ADDENDUM #1 Issued: January 6th, 2023

THE PURPOSE OF ADDENDUM IS TO <u>MAKE CHANGES</u>, AND P<u>ROVIDE ANSWERS TO THE REQUEST FOR</u> <u>CLARIFICATIONS</u> TO THE RFP DOCUMENTS.

Client/Project MONTGOMERY COLLEGE GERMANTOWN CAMPUS OBSERVATION DRIVE SIGN

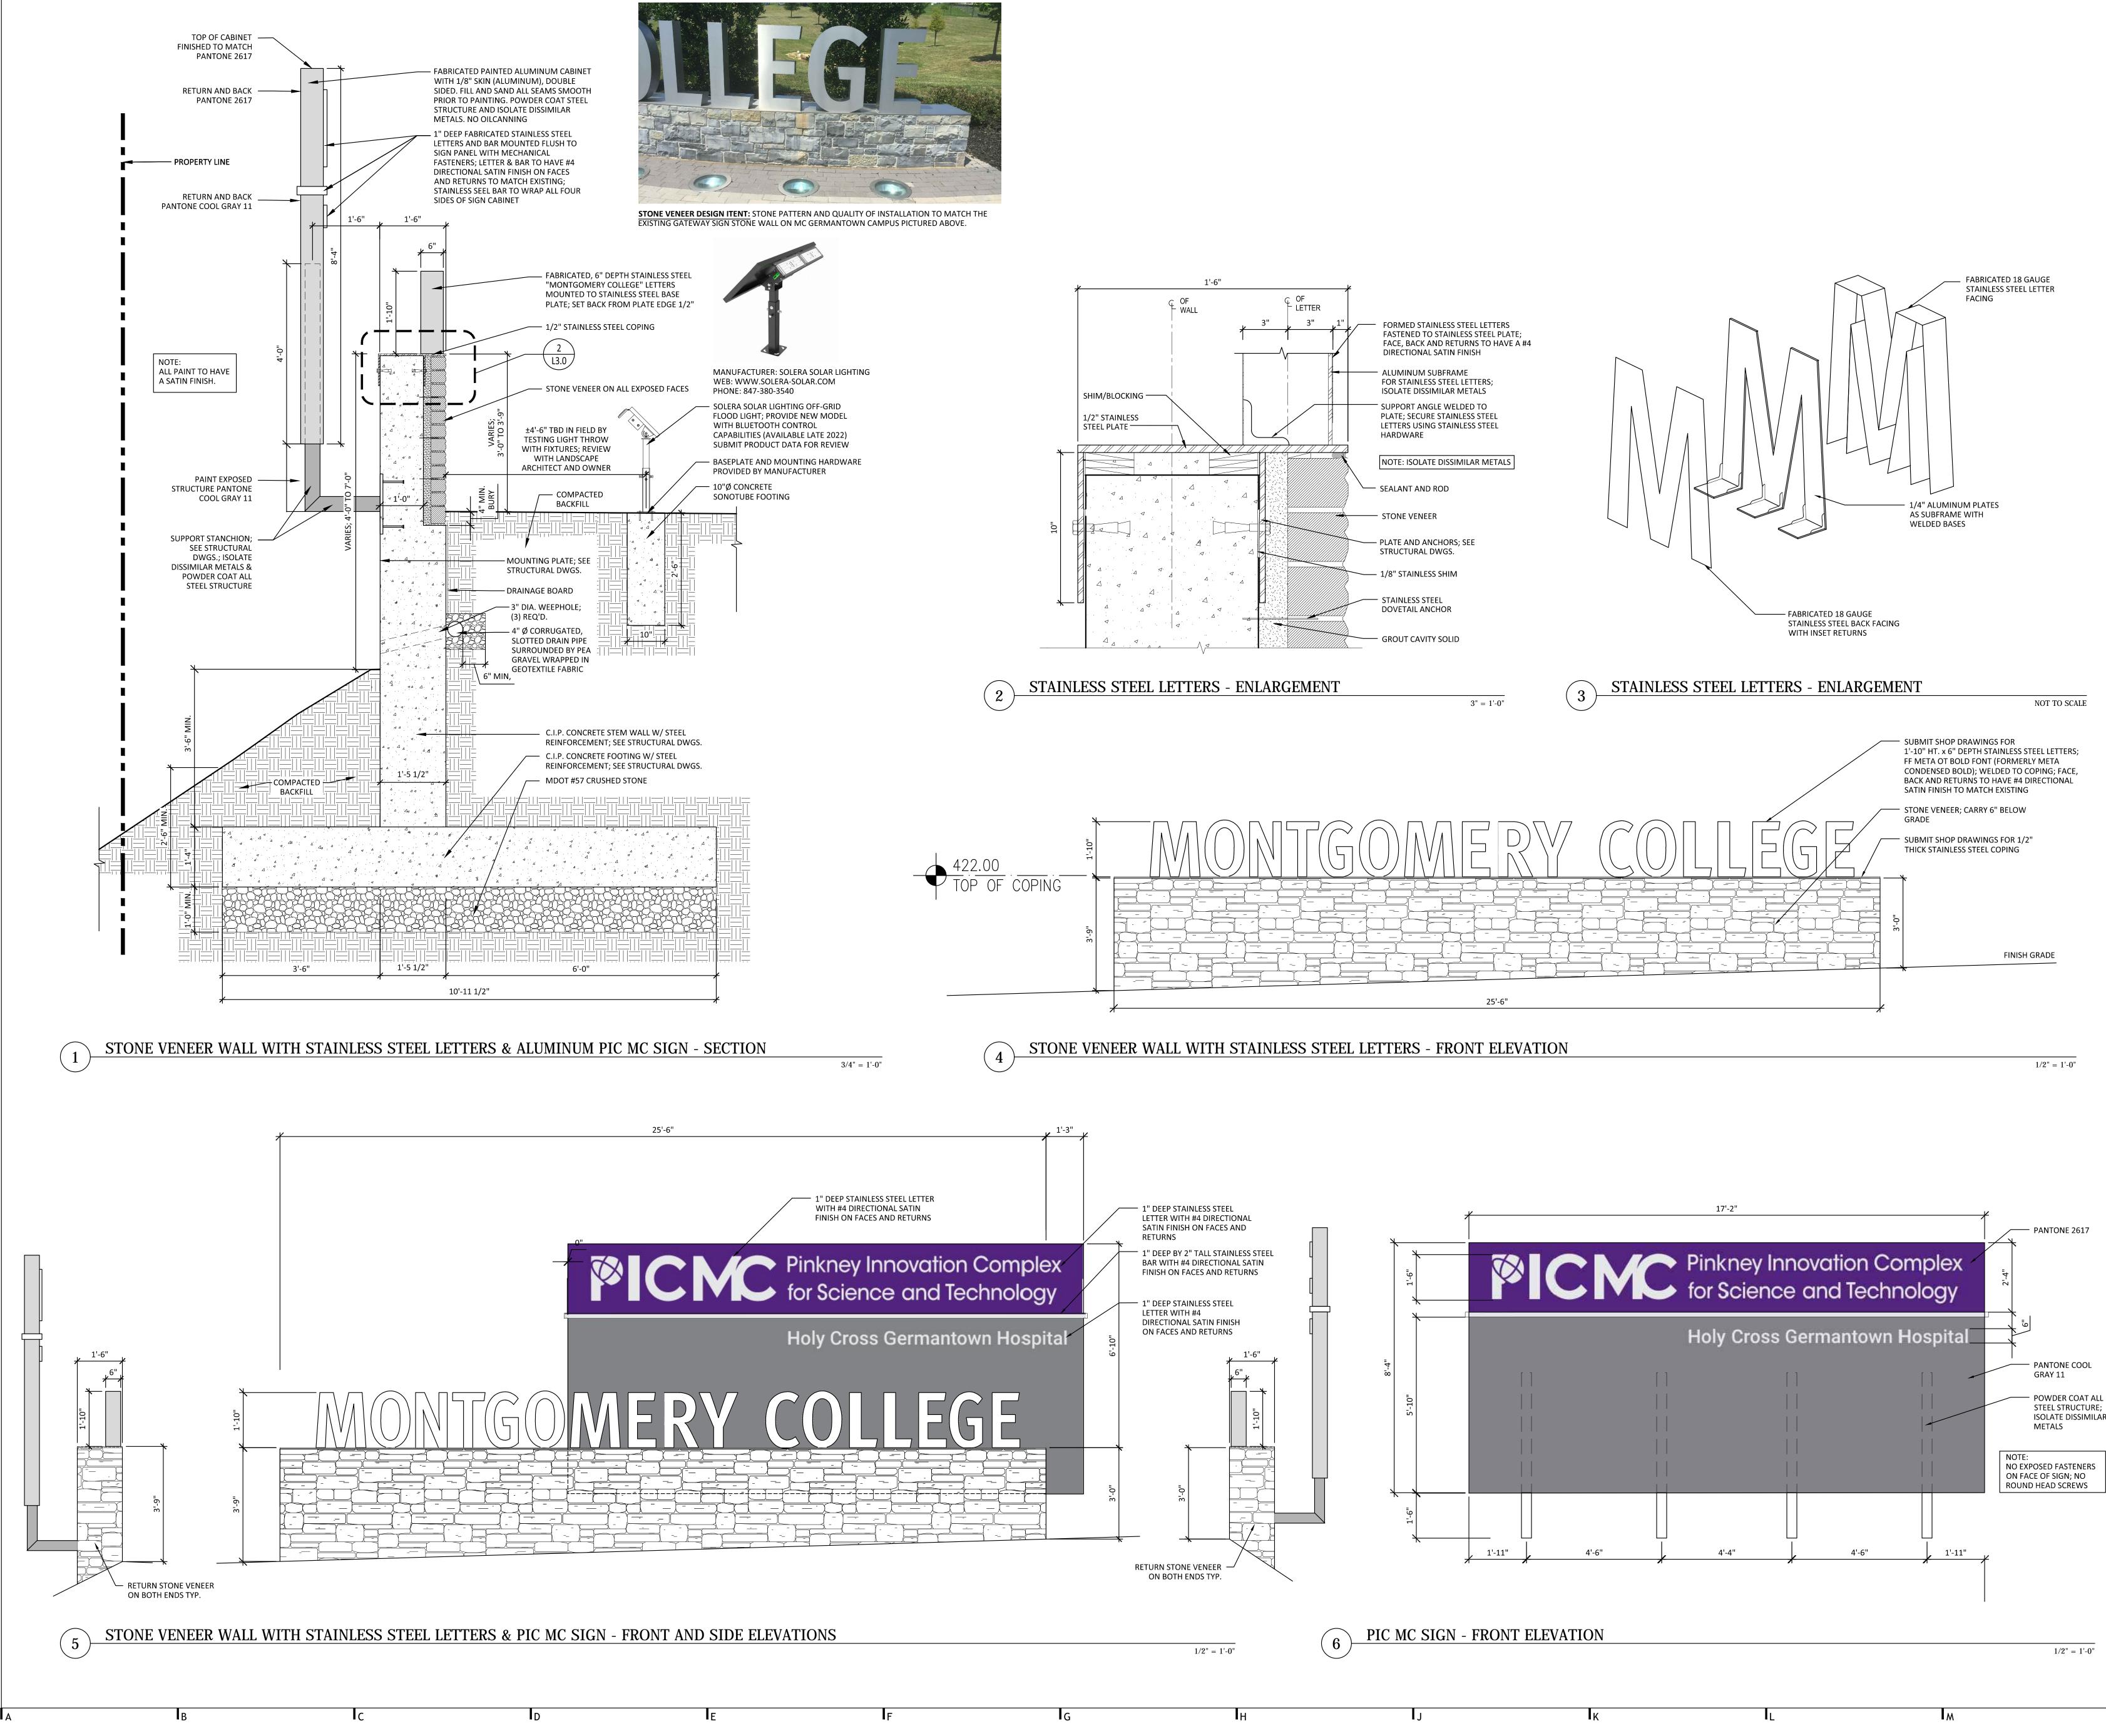
L2.0 – Note added regarding coordination with Washington Gas due to the presence of existing gas lines within the project limits.
